Northern Link Road Tunnel Project

## **Application for Project Change**

October 2010

Figure 4-1: Stage 1 construction sequencing – Western connection

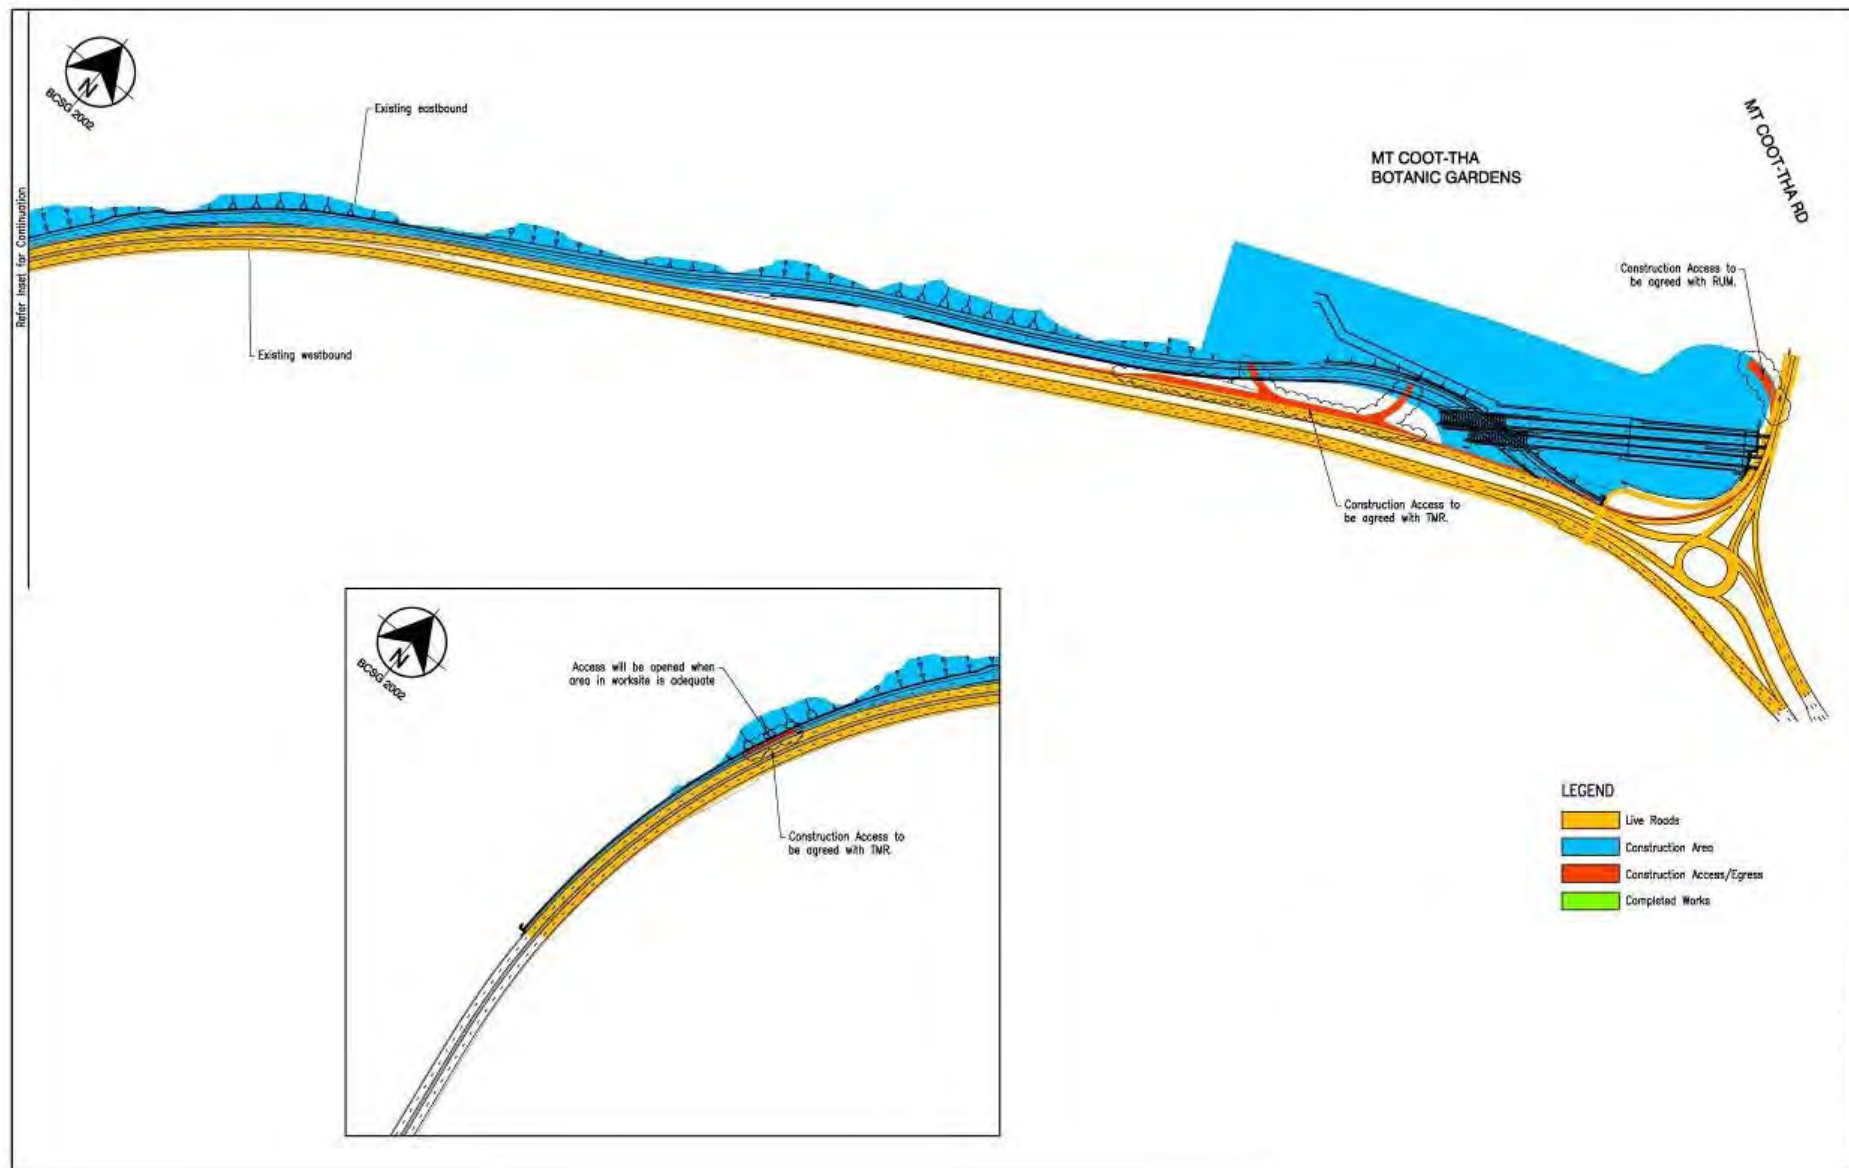
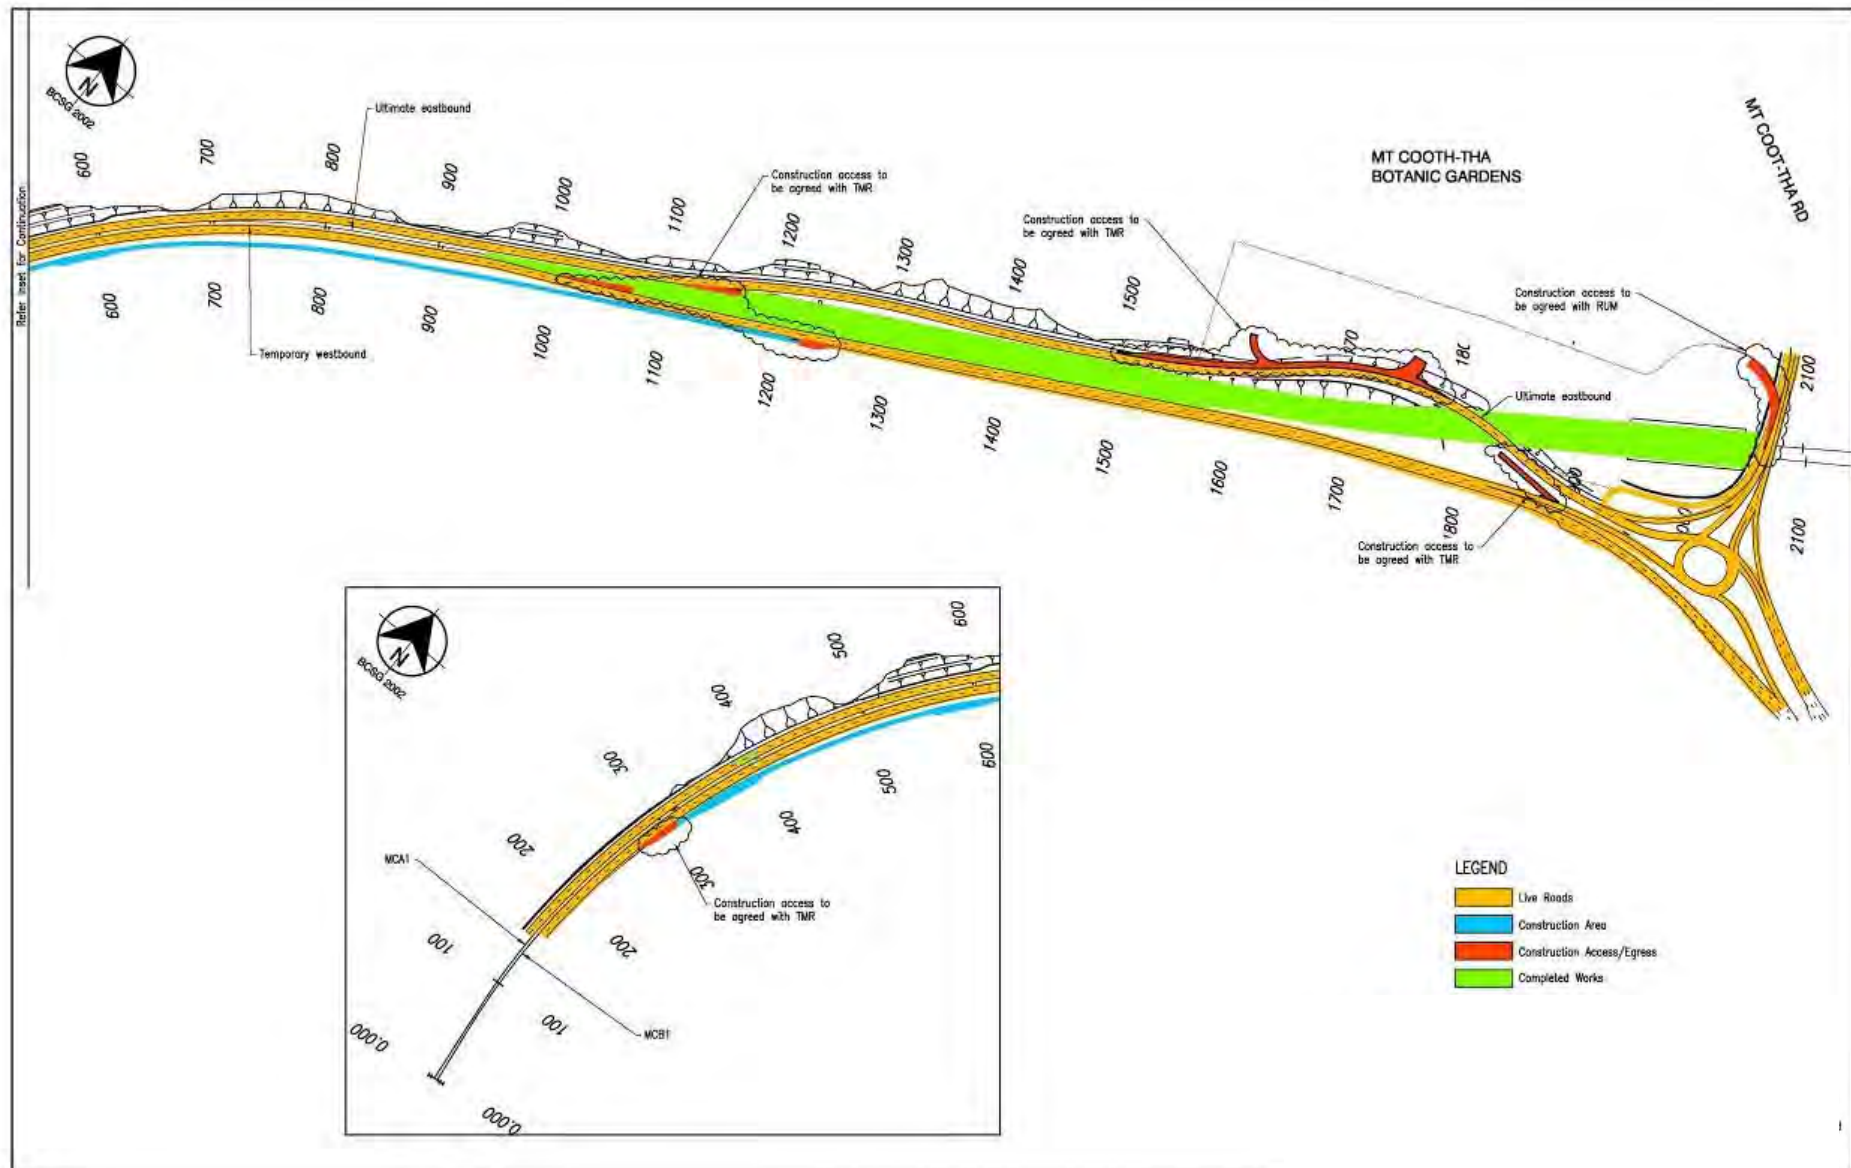
**Figure 4-1**, identifies stage 1, being the establishment of the construction areas and western worksite (blue) to the north of the Centenary Motorway. Construction access and egress (red) would be established off the Centenary Motorway and also off Mt Coot-tha Road, north of the roundabout. The construction of the realigned eastbound lanes of the Centenary Motorway would be off-line with the existing road network unaffected (yellow), apart from access requirements to and from the worksite. Stage 1 would be approximately 26 months in duration and include:

**Figure 4-3** identifies Stage 3 of the delivery of the western connection which would be of approximately 4 months duration and include:

- completion of the ramps and tie-ins to the surface motorway;
- construction drainage work off the existing westbound Centenary Motorway;
- completion of the tunnel fit-out; and
- site demobilisation and urban design and landscape works.

Figure 4-5: Proposed temporary workforce construction parking – Anzac Park

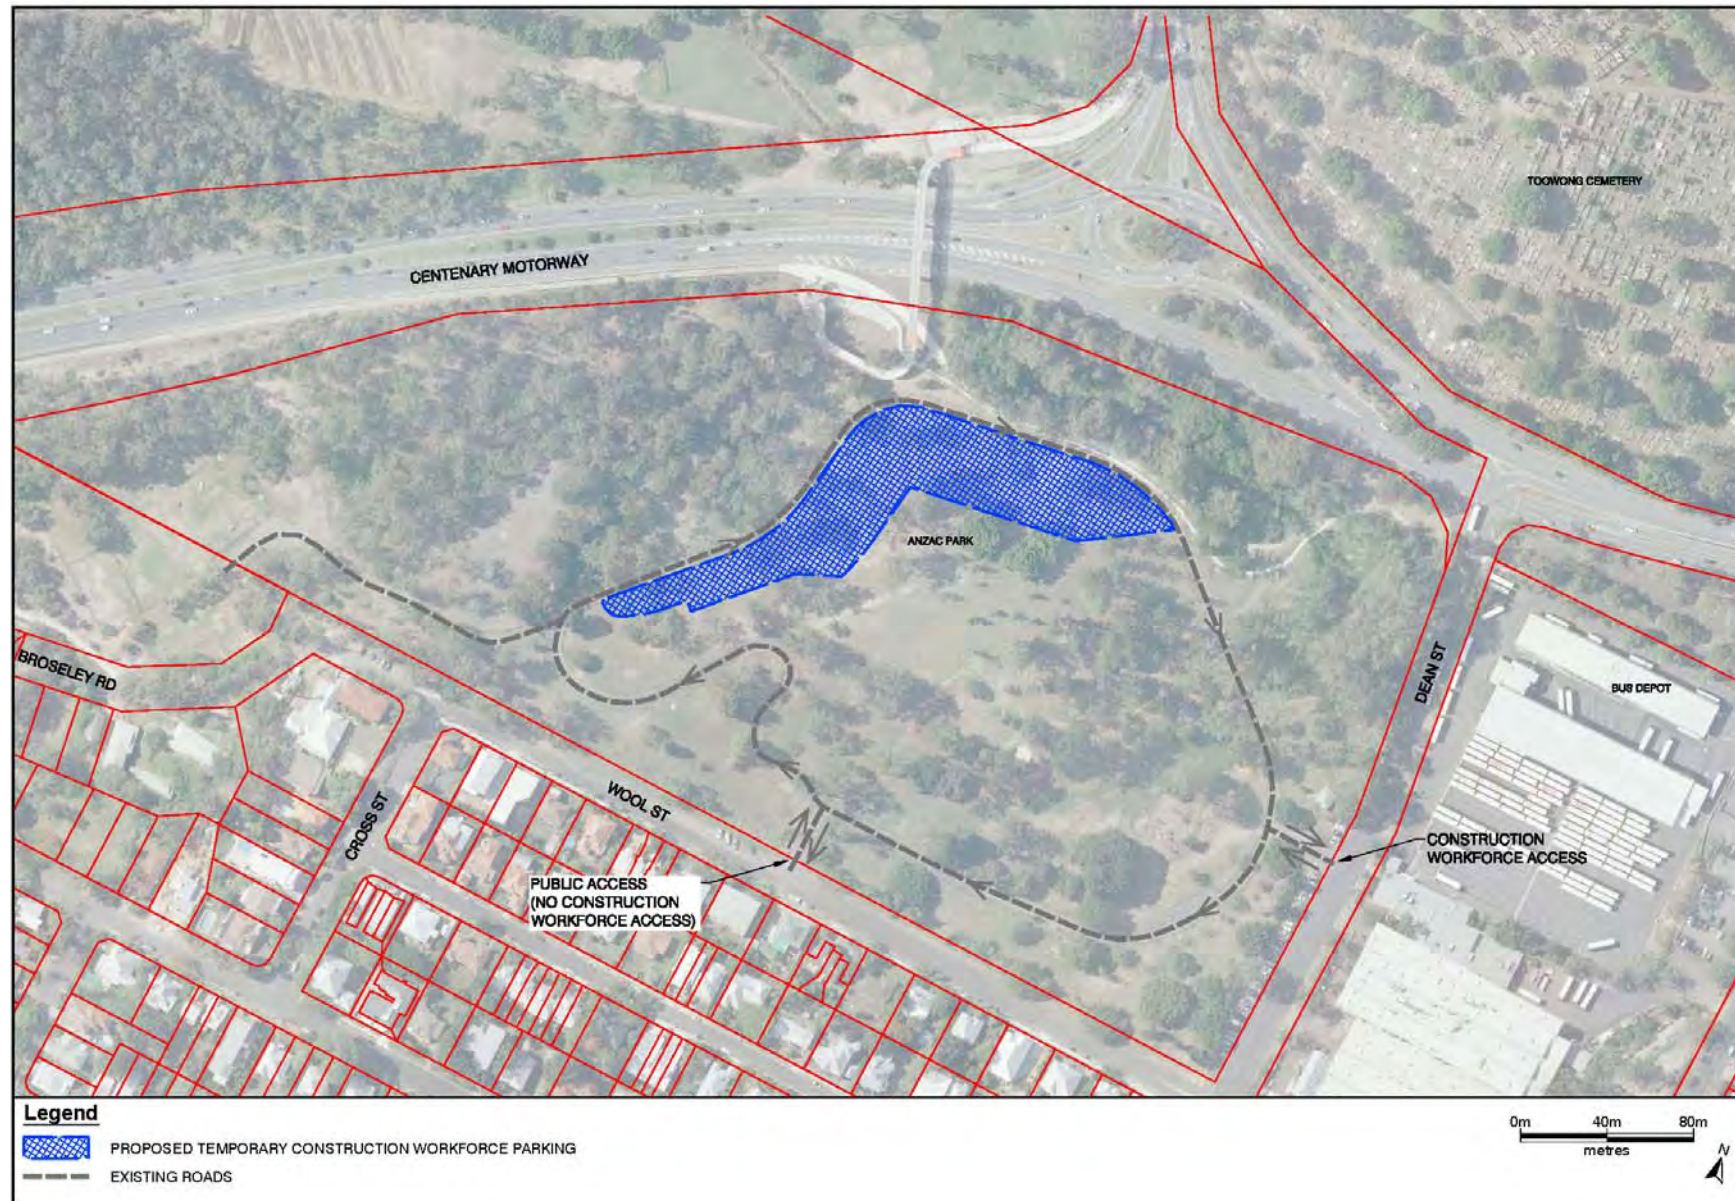
The Changed Project would provide construction workforce car parking in a temporary car park in Anzac Park. This temporary car park would provide up to 300 spaces, with access to the worksite via the pedestrian and cycle bridge over the Centenary Motorway. The temporary car park would not remove any significant trees or require the relocation of any active park use facilities. Access to the park for local people would be maintained at both Dean Street and Wool Street, whereas workers' access would be restricted to access from Dean Street.

A temporary construction workforce parking area for up to 300 vehicles would be provided in Anzac Park, as shown in **Figure 4-5**. This has been included to satisfy the Coordinator-General's condition with regards adequate off-street construction workforce parking to ensure the construction workforce does not park on surrounding local streets. This additional temporary construction parking site would be located in the northern part of Anzac Park, adjacent to the recently-constructed pedestrian and cycle bridge and behind a topographic ridge which would visually separate the site from Wool Street.

Figure 8-1: Minimum construction zone width for future Centenary Motorway widening

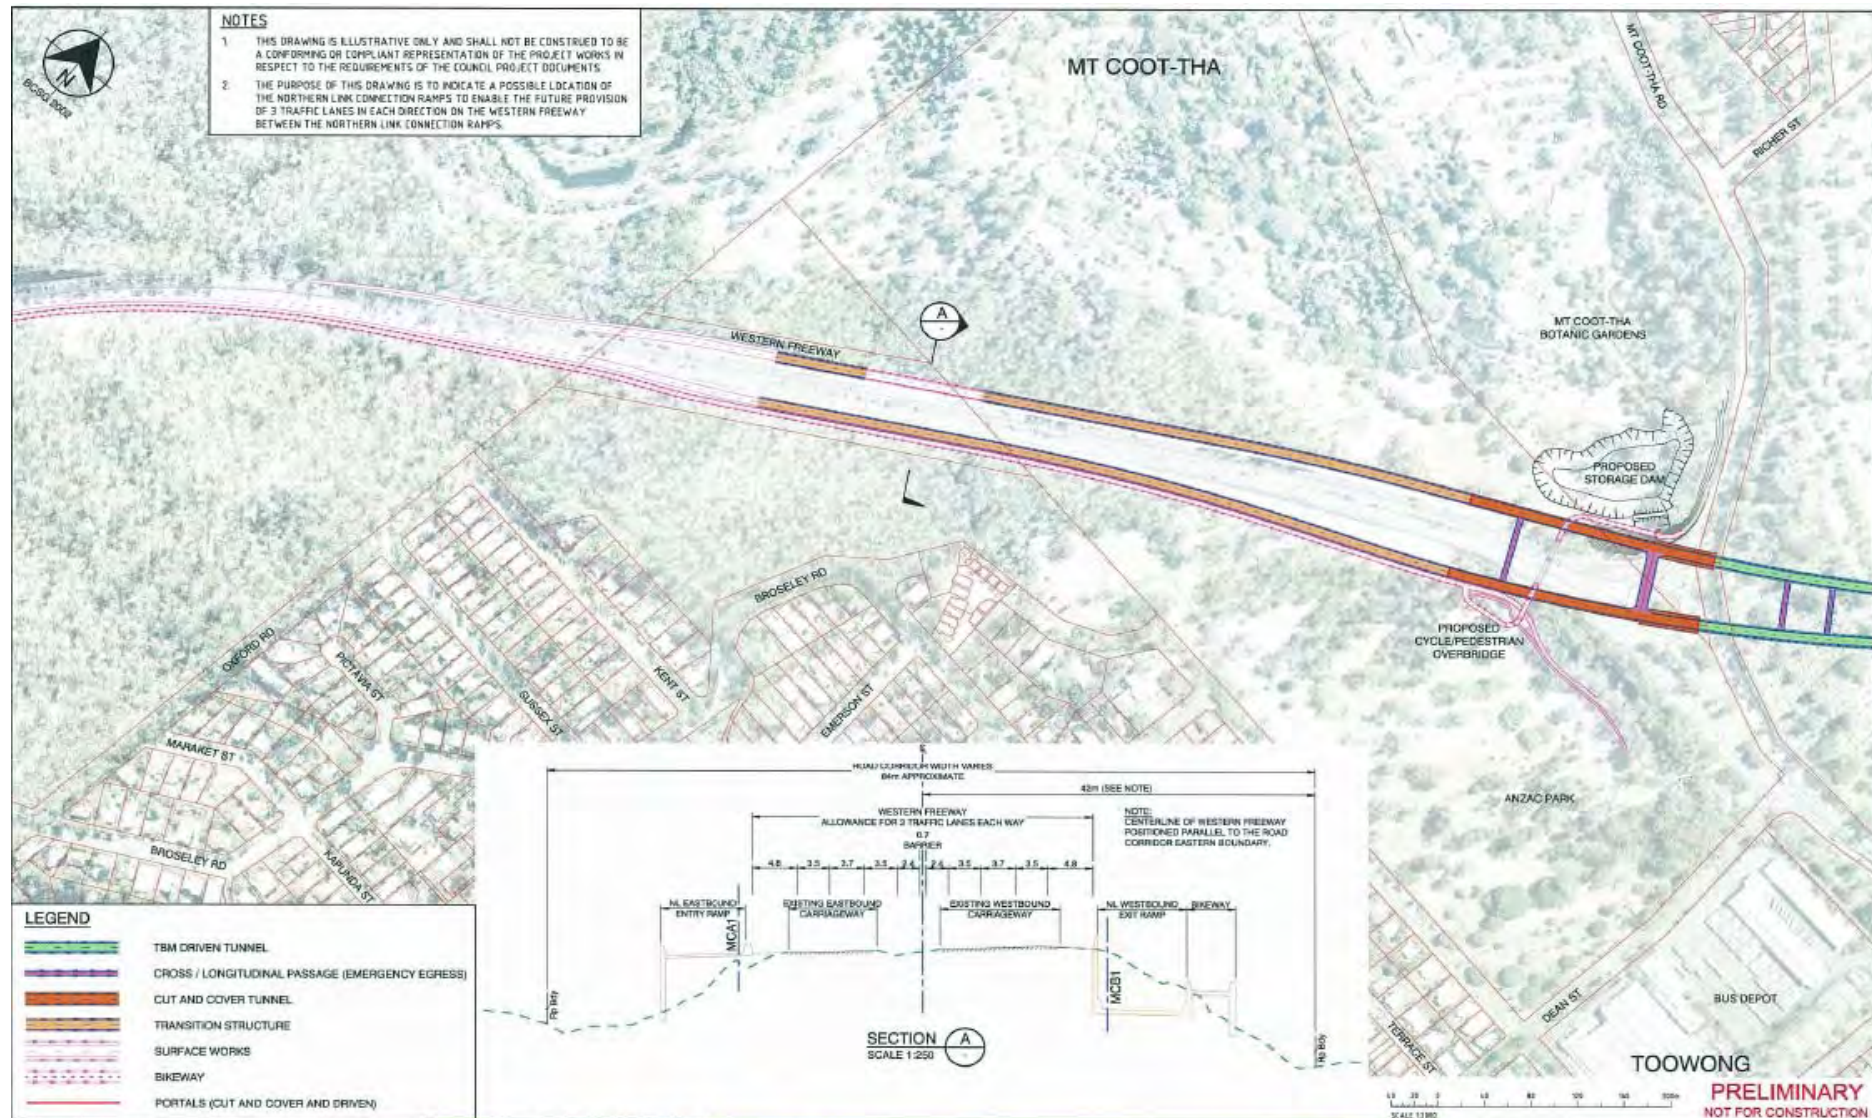
Condition 26(a)(ii) also requires amendment to remove reference to Schedule 8. The Schedule 8 figure relates to the future planning for a new 'Inner Orbital' and specifically the Condition 26(b)(iii) identifying the extent of Northern Link excavation works. A recommended revised Schedule 8 figure to identify the limit of the future construction zone for a possible future widening of the Centenary Motorway is shown below as **Figure 8-2**.

As a consequence of the changes to the connections of the Changed Project with the Centenary Motorway as well as corrections to the existing conditions it is recommended that:

- The following wording is used to replace conditions 26(a)(i) and 26(a)(ii):
  - "Completed earthworks are required for a possible third lane on the left-hand side of the inbound carriageway of the Centenary Motorway between its junction with the Mt Coot-tha intersection and the limit line of below grade Northern Links Works identified in Schedule 8 and being a line drawn between the two points (E46987.038, N157425.253) and (E47071.605, N157283.886).
  - This future construction zone shall exclude structures, drainage pipes, drainage materials (aggregate), lighting columns, conduits, cabling, pits, manholes, etc."
- Schedule 8 is replaced by the **Figure 8-2** above
- Add reference to Schedule 8 to the end of Condition 26(b)(iii), and
- Delete condition 26(b)(iv).
